# MAINTENANCE INSTRUCTION

## MODERNIZATION RECOMMENDATION

### EXHAUST SCREEN INSPECTION PORT FOR REAR EXHAUST MANIFOLD

Fig.1 - Exhaust Screen Inspection Port

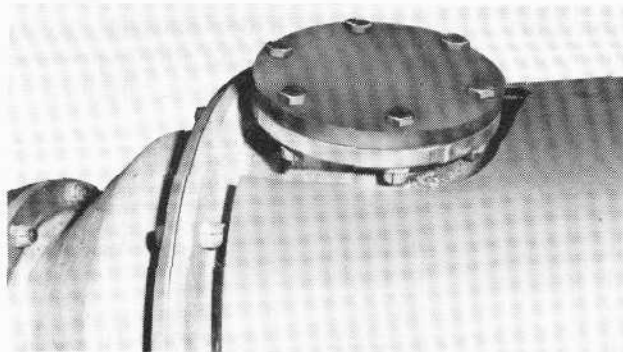
- PURPOSE:** The purpose of this Modernization Recommendation is to provide a procedure for applying an exhaust screen inspection port in the rear exhaust manifold.

- DISCUSSION:** The exhaust screen inspection port for the rear exhaust manifold is now available as kit 9336983. This inspection port has a 4" diameter access opening to view the exhaust screen plate. This will allow the customer to inspect the exhaust screen without physically removing the screen from the manifold.

- The heat shield assembly must also be altered to accept the inspection port. This modification may be performed by the customer or a modified heat shield assembly 9320186 is available.

1. Remove rear exhaust manifold from the engine.
2. Cut 4-5/8" diameter hole in the exhaust chamber as shown in 9336983.
3. Clean surface prior to welding by wire brushing any foreign substance. Remove all oily deposits with commercial solvent.
4. Insert flange tube assembly 9316671 so that the tube penetrates the outer body approximately 3/16" and in the orientation and location as shown in 9336983. Tack weld in place.
5. Weld the tube with the special 8018-B2 welding rod supplied as item No. 6 of the kit. A continuous 3/16" fillet weld (no voids) is required on the inside and outside.

6. Assemble per 9336983 torque all six bolts to 80 ft-lbs.
7. A modified heat shield assembly 9320186 should be used or the original heat shield altered by cutting a 7-1/4" by 6-13/16" slot as shown in 9320184 and 9320185.
8. Remove all welding slag and foreign material from the interior of the assembly. Shot blasting is permissible if all potential shot traps are shielded and the chamber is thoroughly inspected prior to application.
